Access Compliance Report

Public Rights-of-Way

(Curb Ramps)

Intersection ID: 49131	Main Street: EWERT_CUT_LN	Cross Street: WILTSHIRE_RIDGE_RD	Location: W
ADA ID: 1B4DBEB9EEA1	Ramp Type: Perp	Initial Pass/Fail: Fail	Overall Compliance: No
Severity Score: 21.25			
Codes/Mitigation Info/Possible Solution		Field Measurements/Component Compliance

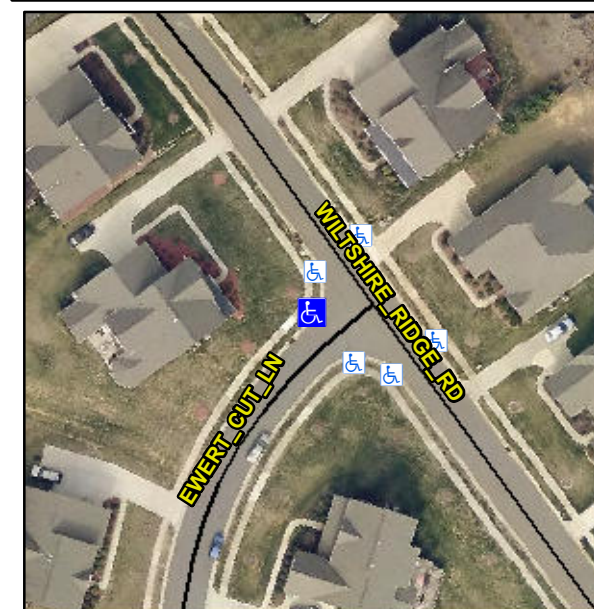
R304.5.1, R304.5.3

Compliance	Description	Data	Compliance	Description	Data
N/A	Ramp Length (in)	48.0	Yes	Ramp Slope (%)	6.3
No	Ramp Width (in)	44.0	No	Ramp XSlope (%)	5.4
N/A	Flare Type LT	N/A	N/A	Flare Type RT	N/A
N/A	Flare Slope LT (%)	N/A	N/A	Flare Slope RT (%)	N/A
N/A	Flare Traversable LT?	N/A	N/A	Flare Traversable RT?	N/A
N/A	Landing Length (in)	N/A	N/A	DWS Provided?	N/A
N/A	Landing Width (in)	N/A	N/A	DWS Contrast?	N/A
N/A	Landing Slope (%)	N/A	N/A	DWS Length (in)	N/A
N/A	Landing X Slope (%)	N/A	N/A	DWS Full Width?	N/A
N/A	Landing Curb? (Y/N)	N/A	N/A	DWS Offset (in)	N/A
N/A	Shared Landing?	N/A			
N/A	Gutter Ponding?	N/A	N/A	Gutter Slope (%)	N/A
N/A	Gutter Lip Ht (in)	N/A	N/A	Gutter X Slope (%)	N/A
N/A	Painted X Walk1?	No	N/A	Painted X Walk2?	N/A
	X Walk 1 Direction	To SE		X Walk 2 Direction	N/A
N/A	X Walk 1 Width (in)	N/A	N/A	X Walk 2 Width (in)	N/A
	X Walk 1 Slope (%)	0.3		X Walk 2 Slope (%)	N/A
	X Walk 1 X Slope (%)	2.3		X Walk 2 X Slope (%)	N/A

Remove & Replace Entire Ramp.
